From: FNAL::JBS 11-NOV-1991 23:23:45.26
To: FNAL::ORRIS
CC: MYSELF
Subj: Long 50 mm magnet inductance

I have done the following exercise with the data from DCA311.QB007 and find the following:

Lower Coils: Inner / Outer

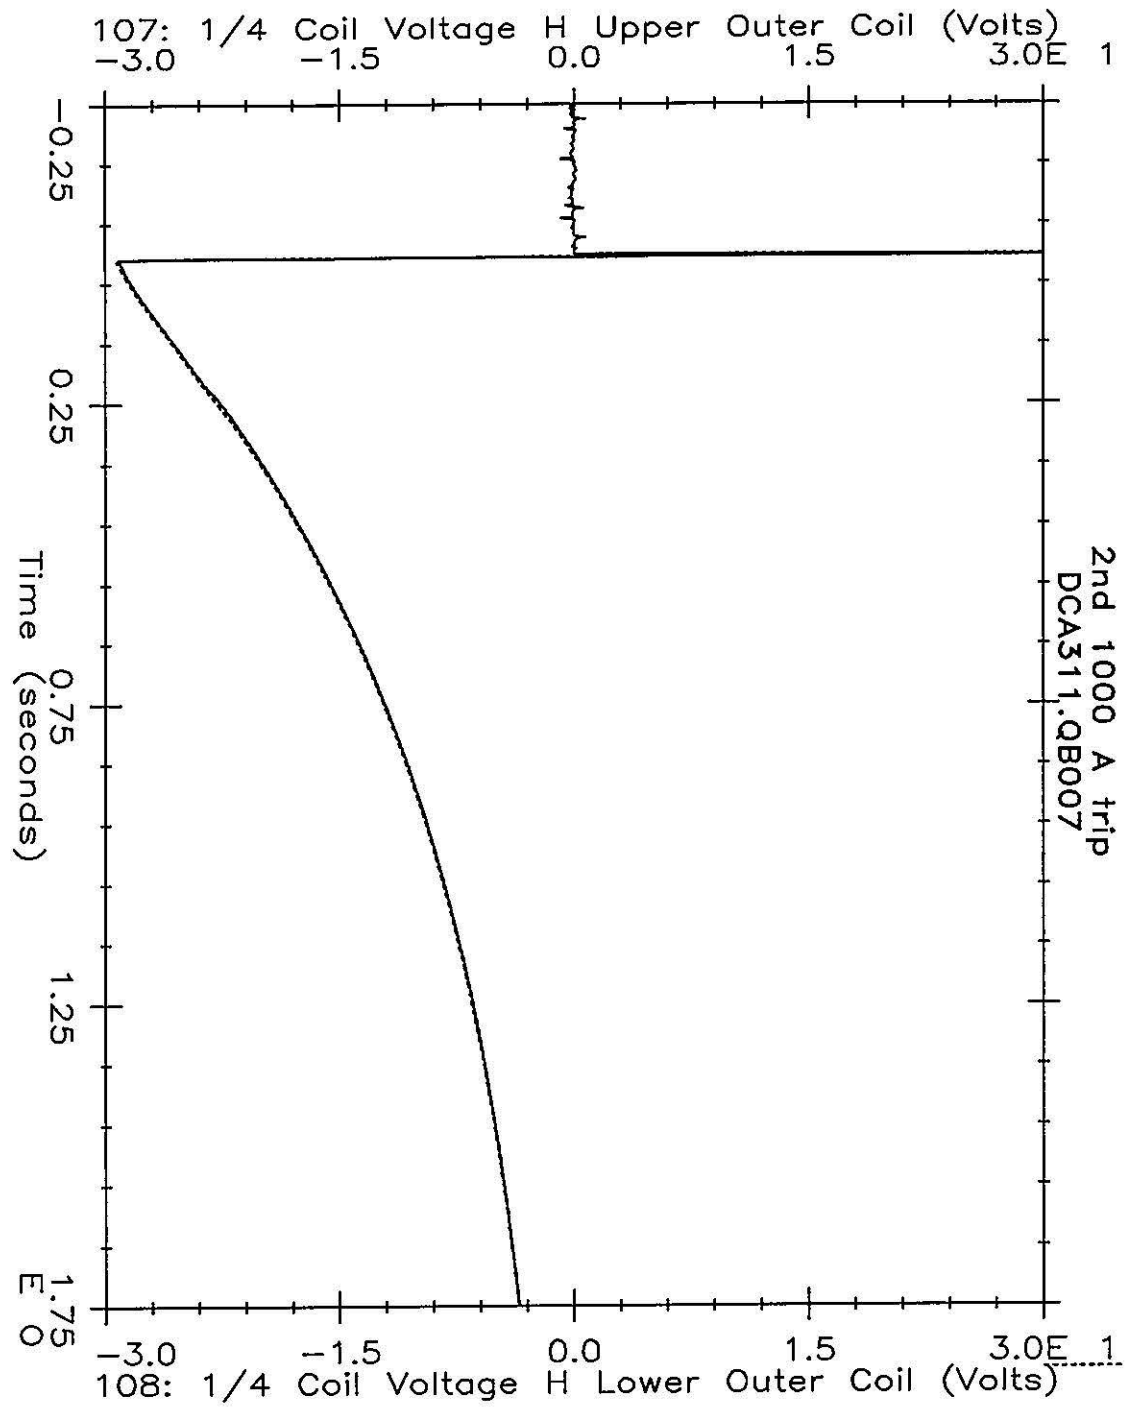
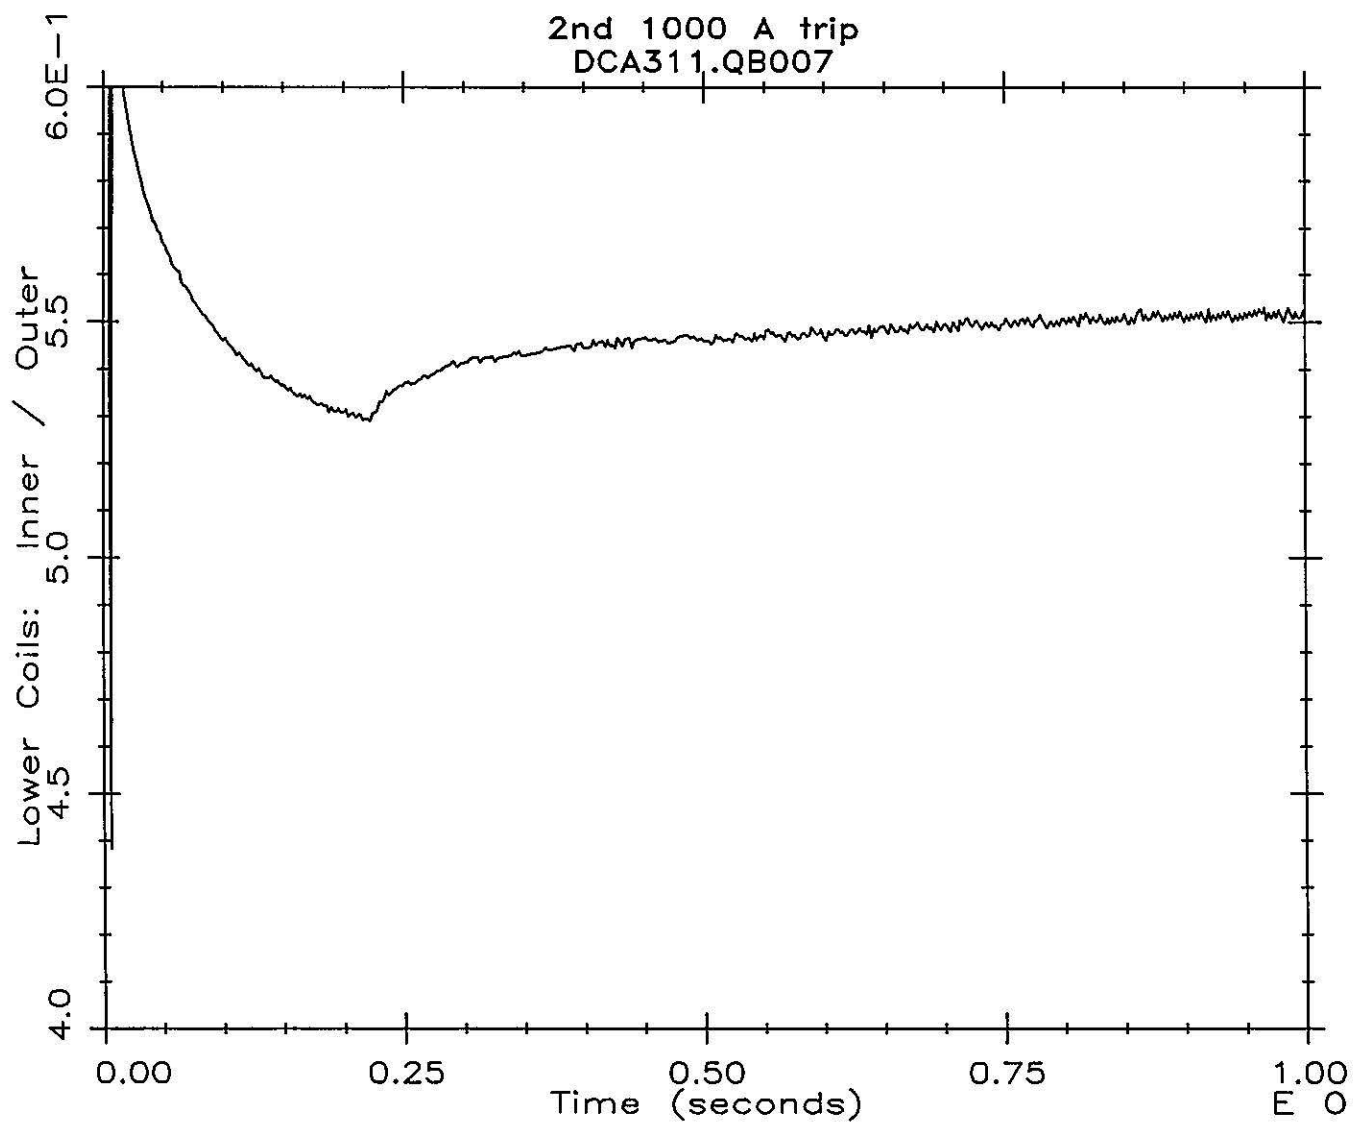
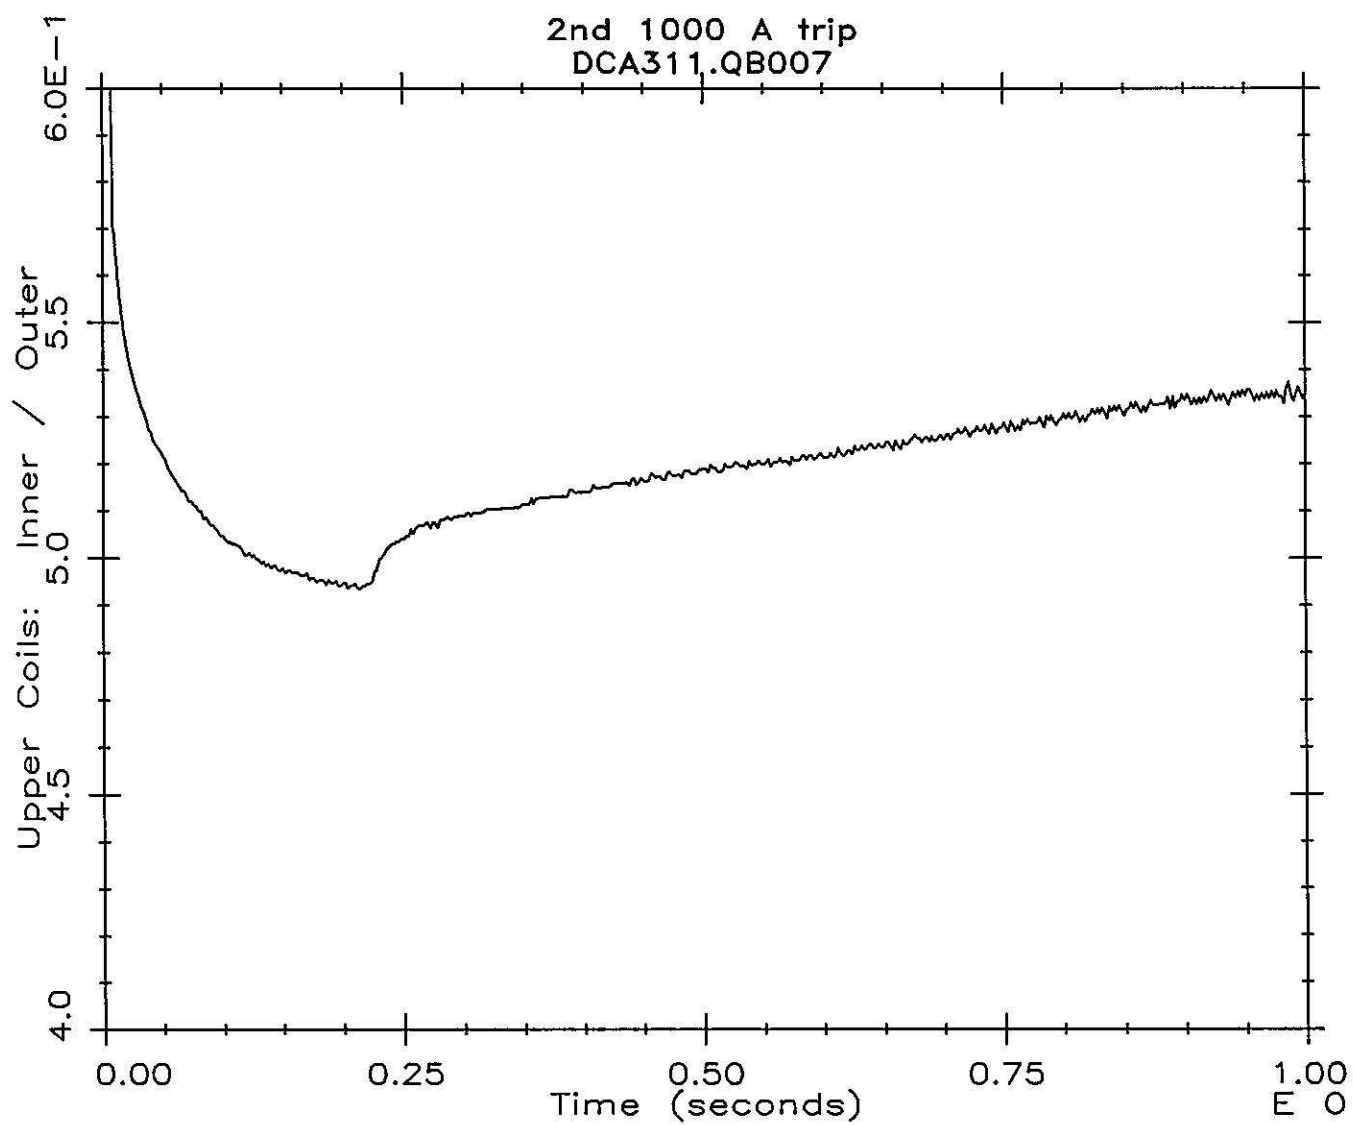
- 3) To get the inner quarter coil inductance fraction I look at the ratio of inner to outer coil voltage. The two outer coil voltages track each other very well, but the inner coils, at least on the high gain channels, differ significantly (on the order of 10%) from each other. The inner coils do not obviously differ from each other by a constant offset or a constant gain difference, so I am not sure what to do. I plotted both the upper inner to outer and the lower inner to outer ratios. The latter was more constant over the period $0.3 < t < 1.0$ sec, so I have chosen to believe that it is more correct. The ratio is not quite constant over this period, however, varying from 0.542 at 0.3 sec to 0.552 at 1.0 sec. I blindly take the average over the this period which turns out to be 0.548. This corresponds to the ratio $L(\text{inner quarter coil}) / L(\text{total}) = 0.177 \pm 0.001$, where the error bar comes from the range of the inner/outer ratio over the time period used. If I use the upper coil ratio, I get something like 0.172 ± 0.002 . If you can sort out the upper inner - lower inner signal difference, we can get a little more solid number.
